R & L CARPENTER ADDITION

WICHITA, SEDGWICK COUNTY, KANSAS

Re: S/D 97-4 -- R. L. CARPENTER ADDITION (Final Plat)

STAFF REPORT
(Final Plat)

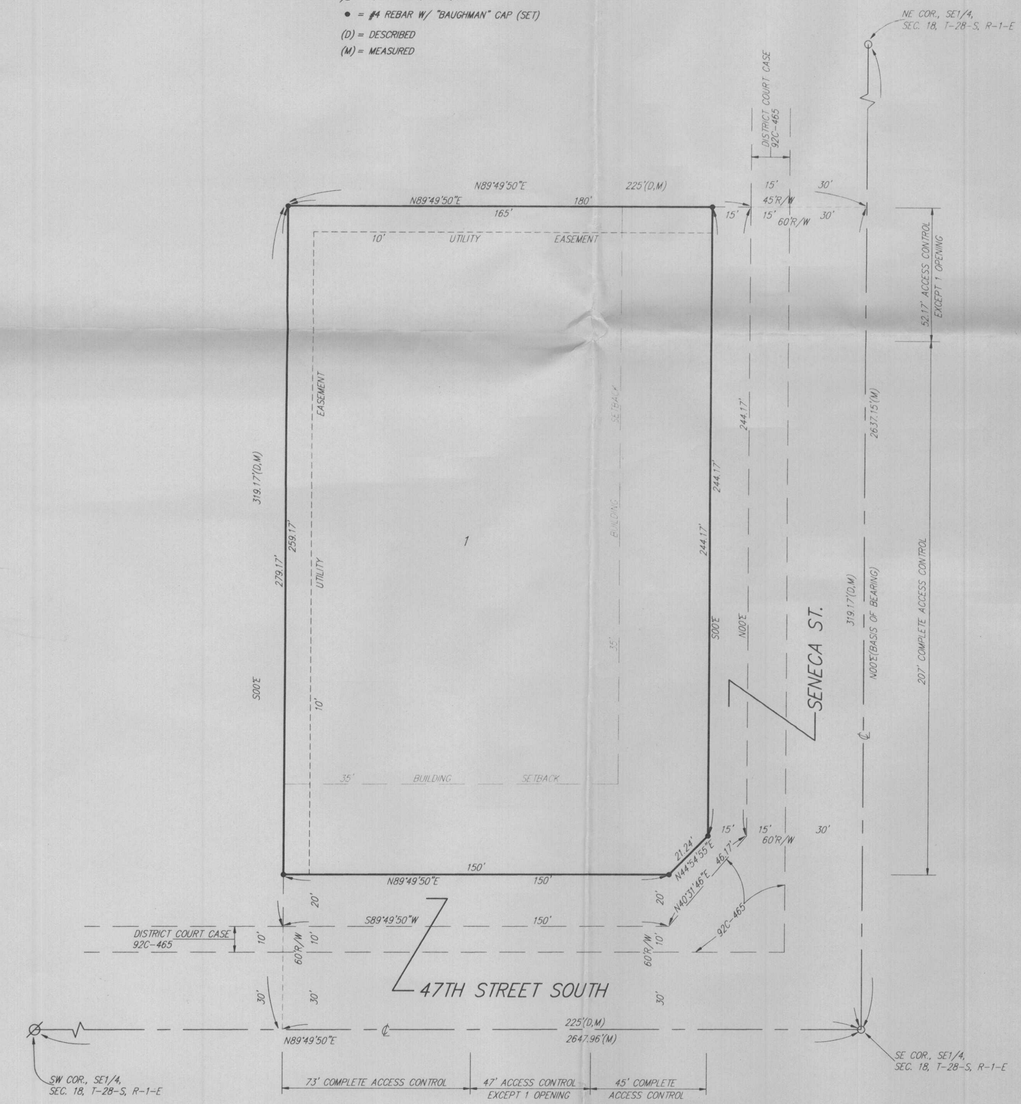
A. The applicant shall guarantee the extension of sanitary sewer to serve the lots being platted. Also, a 10-foot easement along the North line of this plat shall be granted for such sanitary sewer improvements.

B. The applicant shall guarantee any drainage improvements required by the platting of this property. These improvements may be provided at the time of site development.

C. As requested by the applicant, the final plat tracing may indicate 60 foot of half street right-of-way for 47th Street South and Seneca. As required by City Engineering, additional right-of-way at the plat's southeast corner will also be provided.

Complete access control will also be dedicated to 47th Street South across the East 45 feet and West 73 feet of this plat and across the South 207 feet of the site to Seneca. Outside of the areas of complete access control, one opening will be indicated to Seneca and one opening to 47th Street South. The dedication of this access control shall be referenced in the plattor's text in addition to being shown of the face of the final plat tracing.

G. The platting binder also notes that "partial" releases of a number of mortgages are to be filed. If this site is encumbered by any such mortgages, the applicant is advised that these parties need to be made signatories on the plat. If not shown on the final plat tracing, the applicant shall provide proof that all such mortgages have been released for this site.

I. The applicant's engineer is advised that the Register of Deeds is requiring the name(s) of the notary public, who acknowledges the signatures on this plat, to be printed beneath the notary's signature.

K. Perimeter closure computations shall be submitted with the final plat tracing. Section 5-101(c).
